**Operator Presence Water Ball Valve  
Hardware**

**Bulletin Name:** MXR-TSIB-030

**Models:** Bridgemaster Mixer and  
Standard Mixer

Figure 3: Ball Valve Handle Assembly.

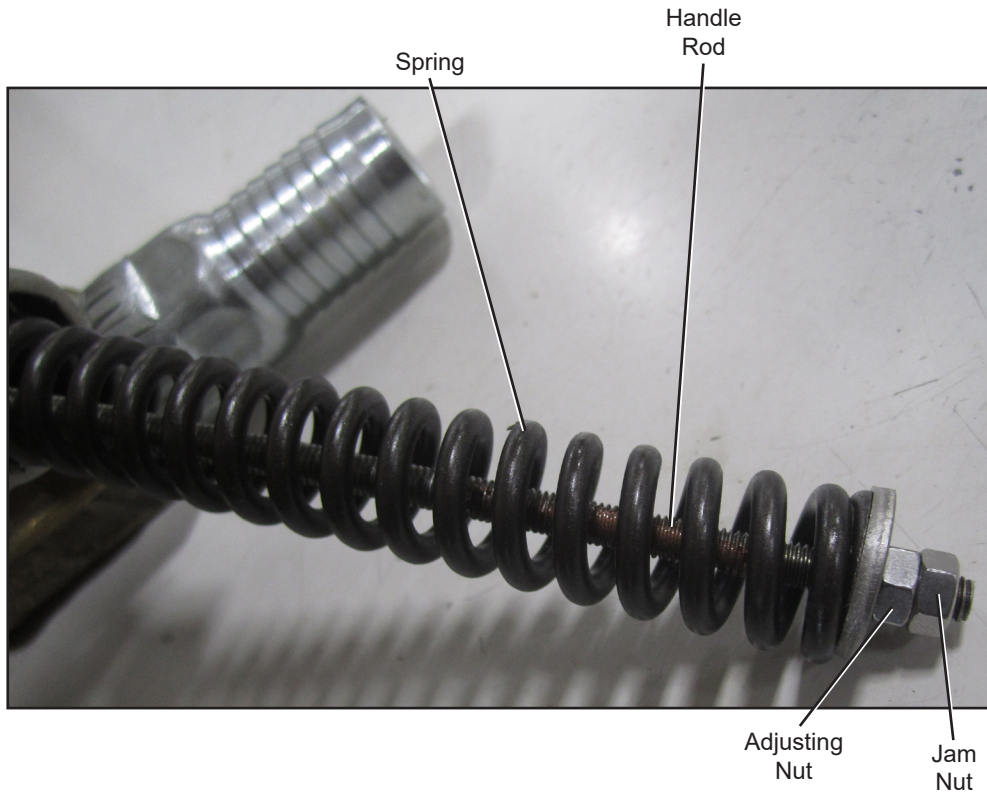
4. Check there are two nuts securing the spring to the handle rod. See Figure 3. If there are two nuts, check that the jam nut is torqued to 4.5 ft.-lbs. (6 N•m), then continue to Step 6. If there is only one nut, continue at Step 5.
5. Install an additional nut (P/N 1245279) onto the rod and use a torque wrench to torque the jam nut to 4.5 ft.-lbs. (6 N•m).
